SUBJECT: Transmittal of Westinghouse Response to Boron Precipitation during LTC Phase

“Boron Precipitation During LTC Phase”

AP1000 DESIGN CERTIFICATION REVIEW

Draft Safety Evaluation Report Open Item Response

Figure 3 – Vertical Flow Regime Map (Taitel-Dukler)

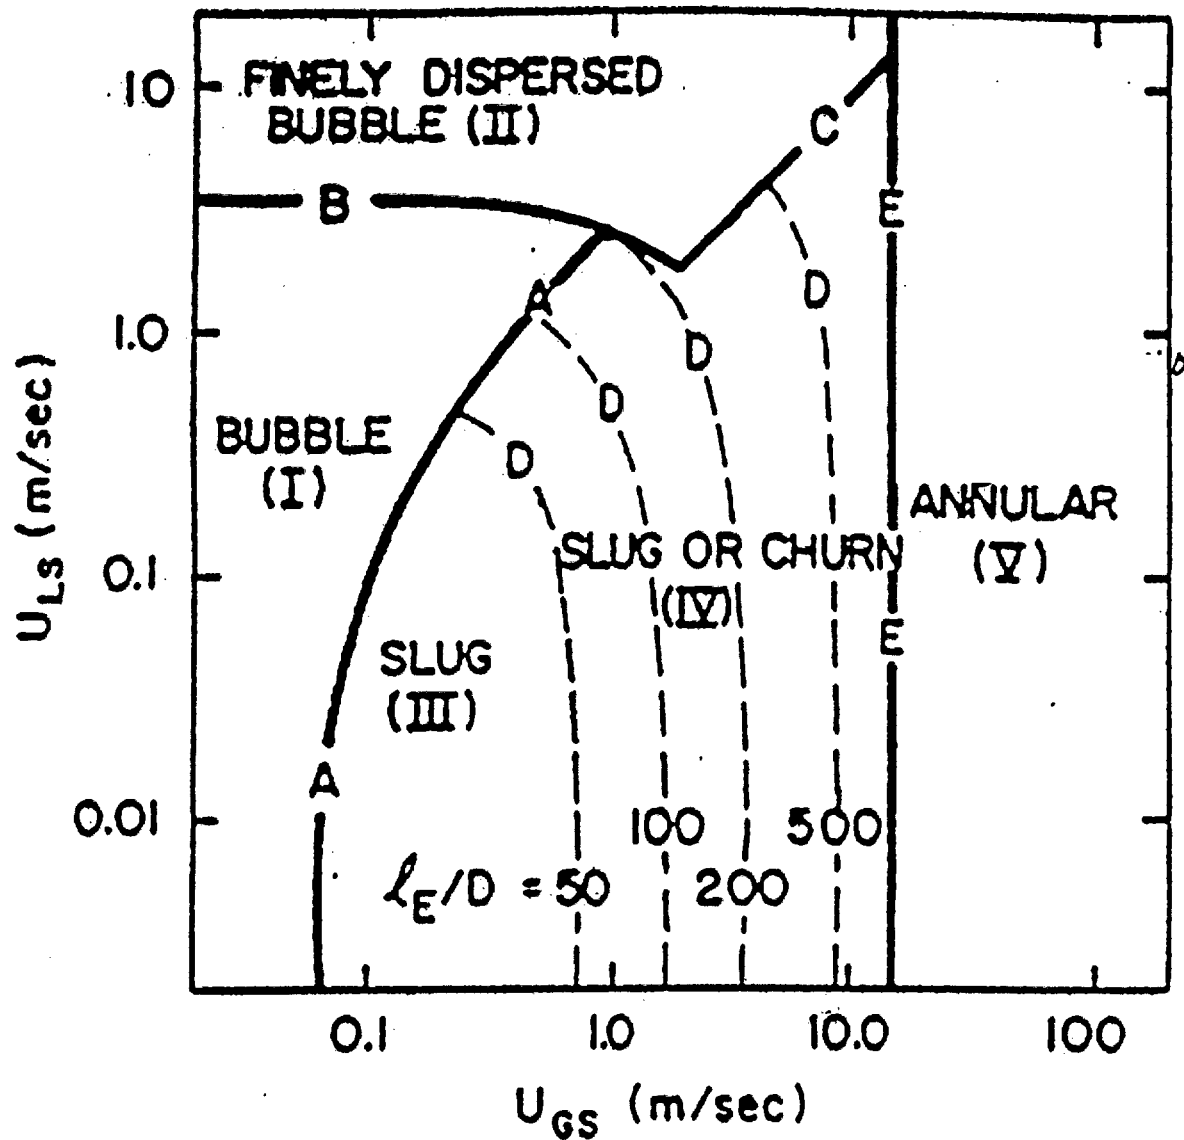
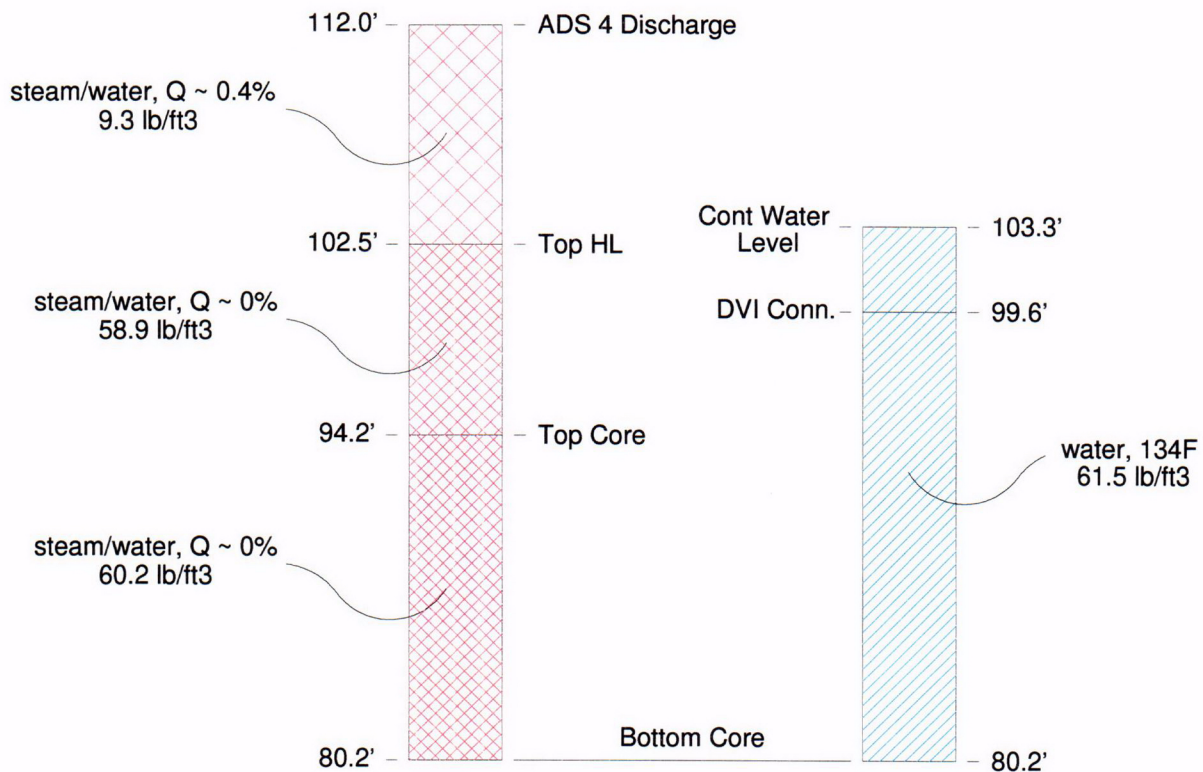
Westinghouse should also address the possible collection of boric acid crystals on the ADS-4 valves and exit piping as these equipment components cool during the event. Justification should be provided to discount the possibility for the ADS-4 valves/piping to become obstructed with boric acid crystals many hours into the event.

10. The 2-phase flow regime is determined at the entrance to the ADS 4 lines where they connect to the HL. This location is considered limiting because the orientation is vertical with upward flow and the velocities at this point are less than those in the individual ADS 4 lines. As a result, if the water can be lifted into the ADS 4 inlet the water will be more easily

pushed out the individual, horizontal ADS 4 lines. The Taittel-Dukler vertical flow regime map (Figure 3) is used to determine the flow regime in the ADS 4 inlet lines.

For each analysis, the ADS 4 vent quality and the flow regime at the inlet to the ADS 4 line is shown in Table 4. For the maximum quality set, the ADS 4 flow regime is annular out through 14 days and then changes to slug/churn. For the best estimate quality set, the ADS 4 flow regime is annular out through 1 day, is slug/churn out through 14 days and then changes to slug flow. The minimum quality set has bubble flow from early on; the main driver for this is the very low decay heat assumed (just after refueling).

For the maximum and best estimate sets, the flow regime (annular, slug/churn, slug) is sufficient to move the water out the ADS 4 flow path. However, for the minimum set it is not obvious that bubble flow can move water out the ADS 4 vent.

Figure 5 – AP1000 Post LOCA Boron Concentration

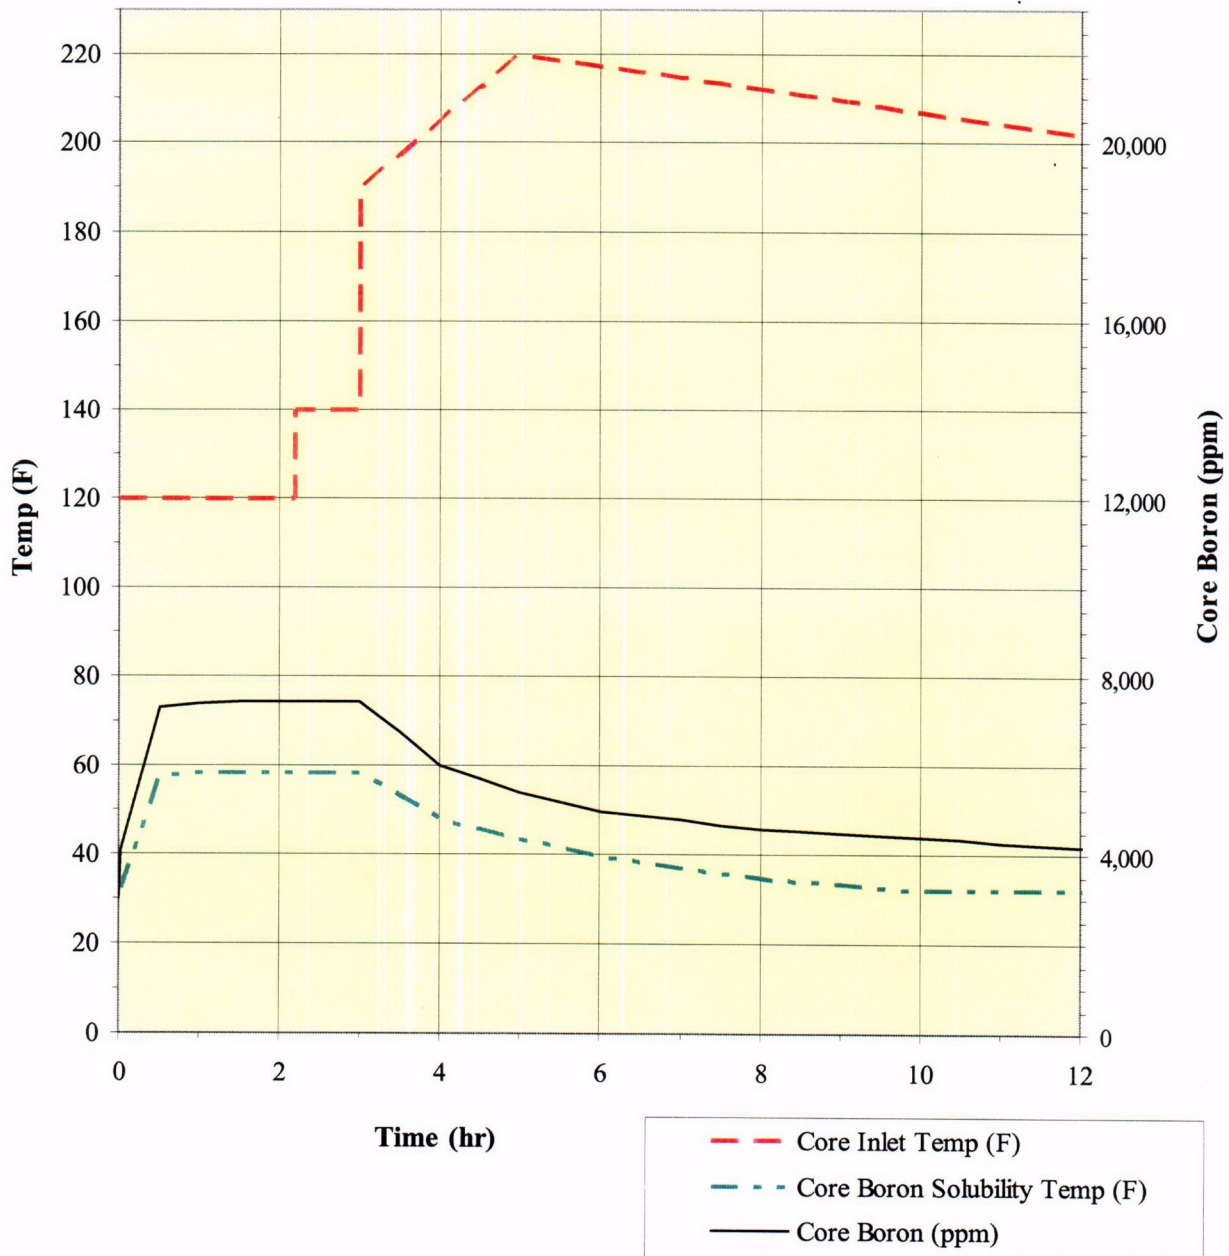
As the core cools, the increase in coolant boric acid concentration is arrested. However, a high boric acid concentration remains in the core many hours into the event. Westinghouse must demonstrate that as the core becomes increasingly subcooled, these high boric acid concentrations will not result in boron precipitation in the core and that the analysis takes into consideration the effect of coolant temperature on boron solubility. Westinghouse should also demonstrate that the concentrations in the sump also do not approach precipitation limits at the maximum sump temperature subcoolings.

The core concentration starts at about 2980 ppm and reaches a maximum value of 7400 ppm in about 2.4 hours. By 6 hours the concentration has dropped below 5000 ppm. Figure 5 shows the calculated AP1000 core boron concentration as a function of time. This figure also shows the solubility temperature of the boron solution in the core. When the core is at its maximum concentration of 7400 ppm the solubility temperature is 58 F. The core inlet temperature will be well above this temperature based on several considerations.

Note: This figure uses a conservative maximum ADS 4 vent quality based on WCOBRA-TRAC and hand calculations. The quality is 60% for the first 3 hours and then decreases.
